## Exhibit A

### Recommended Amendments to the 2018 International Building Code City of Amarillo, Texas

**FIGURE 1511.3.1.1 HAIL EXPOSURE MAP**

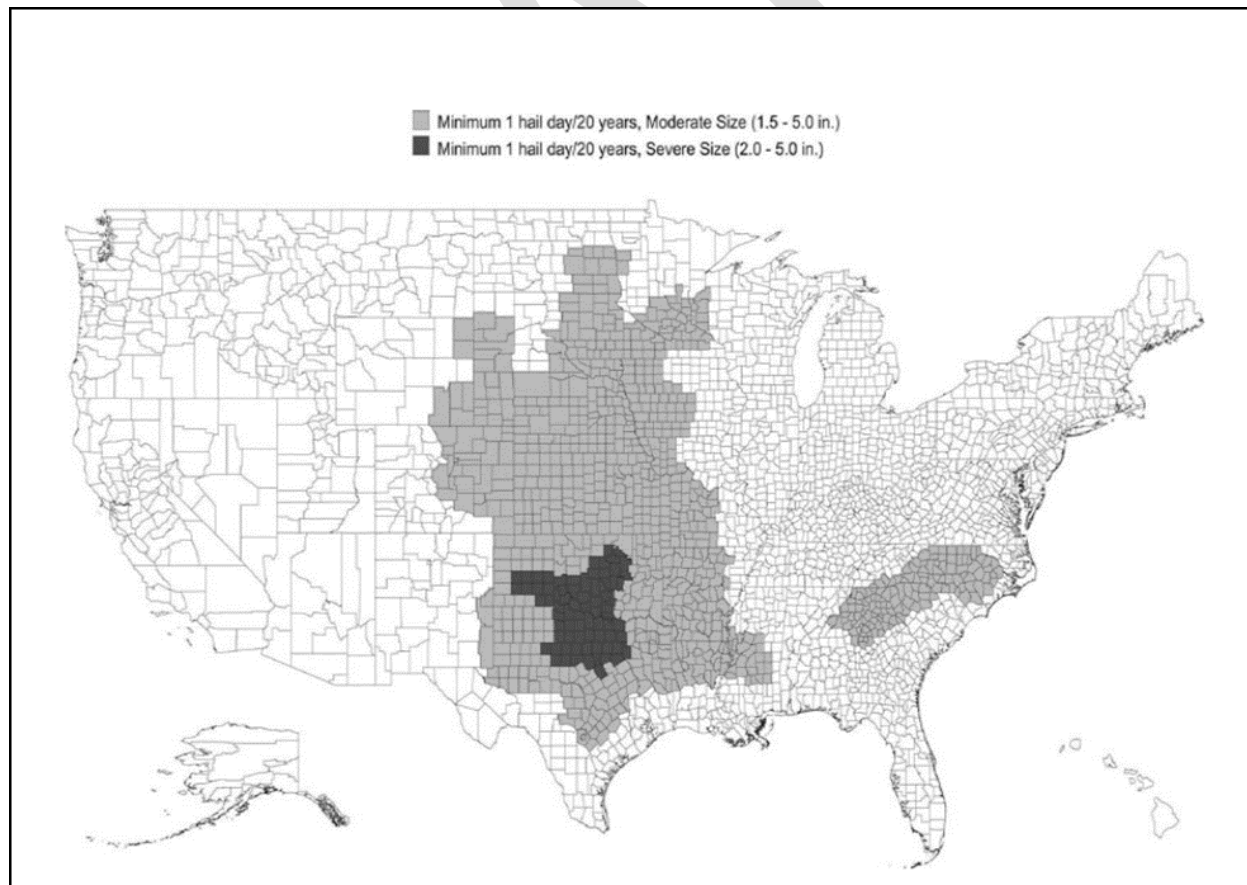
**\*\*Section 1511.3.1.1; insert Figure 1511.3.1.1; change to read as follows:**

1. Where the existing roof or roof covering is water-soaked or has deteriorated to the point that the existing roof or roof covering is not adequate as a base for additional roofing.
2. Where the existing roof covering is wood shake, slate, clay, cement or asbestos-cement tile.
3. Where the existing roof has two or more applications of any type of roof covering.
4. For asphalt shingles, when the building is located in an area subject to moderate or severe hail exposure according to Figure 1511.3.1.1.

*(Reason: Due to the of weather in the Panhandle, wind and hail damage is more prone when asphalt shingles used for re-covering; contractors unable to verify if any of the decking may need to be replaced and unable to verify the flashing integrity)*

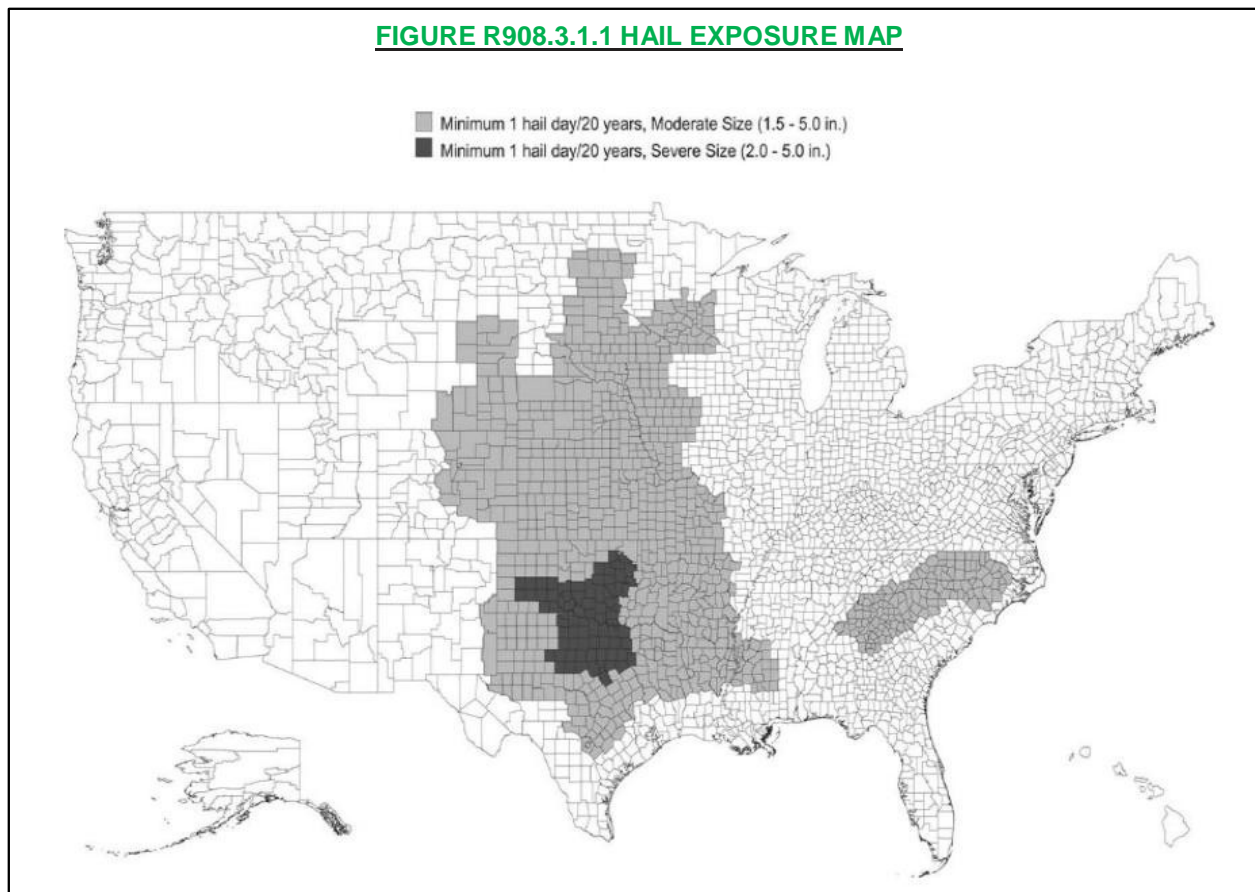
**\*\*Section R908.3.1.1; insert Figure R908.3.1.1; change to read as follows:**

1. Where the existing roof or roof covering is water-soaked or has deteriorated to the point that the existing roof or roof covering is not adequate as a base for additional roofing.
2. Where the existing roof covering is wood, slate, clay, cement or asbestos-cement tile.
3. Where the existing roof has two or more applications of any type of roof covering.
4. For asphalt shingles, when the building is located in an area subject to moderate or severe hail exposure according to Figure R908.3.1.1.

*(Reason: Due to the of weather in the Panhandle, wind and hail damage is more prone when asphalt shingles used for re-covering; contractors unable to verify if any of the decking may need to be replaced and unable to verify the flashing integrity; roof framing practices in the Panhandle have typically utilized 2 x 6 framing members, not designed for the additional weight of a second layer of shingles.)*
